Sales and Service

Correcting the Print on the Marked Tubes of the Forced Stop Input Cable (Q170DEMICBL□M)

4. Forced Stop Input Circuit

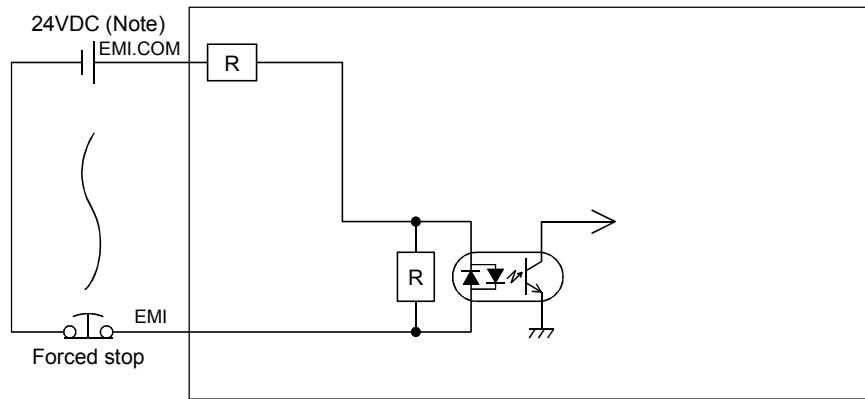
<Before correction> White cable: "EMI", Black cable: "EMI.COM"

<After correction> White cable: "EMI.COM", Black cable: "EMI"

The forced stop input circuit is configured as shown in the following figure.

Since the photocoupler works in both directions, the circuit operates normally even though the 24VDC power supply is connected in reverse. Therefore, the replacement of the currently used cable is not required.
